**CITY OF KELOWNA
MEMORANDUM**

Date: April 1, 2005
File No.: OCP05-0001/Z05-0004
To: CITY MANAGER
From: PLANNING AND CORPORATE SERVICES DEPARTMENT
Subject:

APPLICATION NO. OCP05-0001/Z05-0004 **OWNER:** The Roman Catholic Bishop of Nelson
AT: 790, 796, 798, and 804 Elliot Ave. **APPLICANT:** Immaculate Conception Church (c/o Hans Berger & Ted Matte)

PURPOSE: TO AMEND THE OFFICIAL COMMUNITY PLAN FUTURE LAND USE DESIGNATION FROM THE SINGLE/TWO UNIT RESIDENTIAL TO THE MULTIPLE UNIT RESIDENTIAL – LOW DENSITY DESIGNATION.

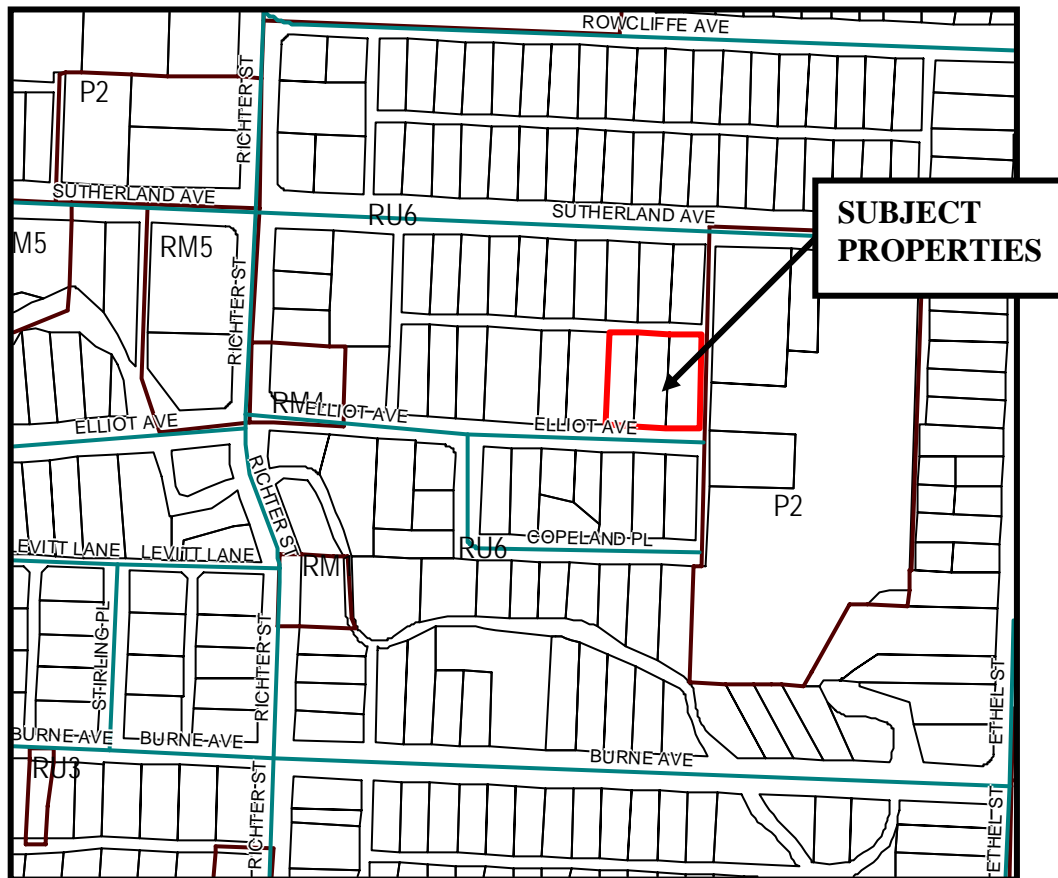
CRITERIA	PROPOSAL	RM5 ZONE REQUIREMENTS
Lot Area (m ²)	2477.0 m ² (existing three lots) – 86.7m ² (road dedications) = 2390.3 m²	1400 m ²
Lot Width (m)	55.54 m	30.0 m
Lot Depth	50.0 m	35.0 m
Floor Area Ratio (F.A.R.)	1.30*	1.1 plus 0.1 for housing agreement, plus maximum of 0.2 for parking below habitable space $1.1 + 0.1 + (12/45 \times 0.2) = 1.25$
Site Coverage (buildings)	46.8% = 1118.33 m ² / 2390.3 m ² (without lane closure)* 42.8% = 1118.33 m ² / 2677.5 m ² (with lane closure)	40%
Site Coverage (buildings/parking)	59.1% = 1411.63 / 2390.3m ²	60%
Height	15.8 m	16.5 m or 4 storeys
Setbacks (m) from new property lines after road dedications

- Front	3.87 m*	6.0 m
- Rear	6.75 m*	9.0 m except 7.5 m to rear lane
- Side (east)	3.81 m*	4.5 m < 2 ½ storeys 7.5 m > 2 ½ storeys
- Side (west)	4.5 m < 2 ½ storeys 4.5 m to 3 rd floor * 7.5 m to 4 th floor	4.5 m < 2 ½ storeys 7.5 m > 2 ½ storeys

Other requirements		
Parking Stalls (#)	24 spaces *	Congregate housing: 1 per principal dwelling, plus 1 stall per three bed spaces and 1 per resident staff member. Apartment housing: 1.25 per 1-bdrm unit, 1.5 per 2-bdrm unit. $(1.25 \times 9) + (1.5 \times 17) + (21/3) + 1$ for resident manager = 45 spaces
Bicycle Stalls (#)	0 *	Class I: 1 per 25 employees Class II: 5 per public entrance
Projections	South (front) – 5.0 m projection into required front yard were 3.0 m is permitted* East - 0.0m setback to property line where 1.5 m setback required *	Entrance canopies or awnings in for weather protection or building ornamentation may project no more than 3.0 m into a front yard or no closer than 1.5 m to a side lot line. Unenclosed steps, eaves, awnings, decks, canopies, balconies, or porches may project into a required yard provided such projections do not exceed 0.6 m in the case of a front or side yard on a flanking street, 0.6 m in the case of an interior side yard, and 2.5 m in the case of a rear yard greater than 6.0 m.

Continuous building frontage	Conforming building frontage. Non conforming transition in height *	No continuous building frontage shall exceed 40.0 m for a 3 or 4 storey building. The building must be designed so that the portion adjacent to neighbouring development is no more than ½ storey higher.
Open Space	Conforms	7.5 m ² per bachelor dwelling, 15 m ² per one bedroom dwelling, and 25 m ² per dwelling above one bedroom (765 m ² required)

* does not conform to the Zoning Bylaw.
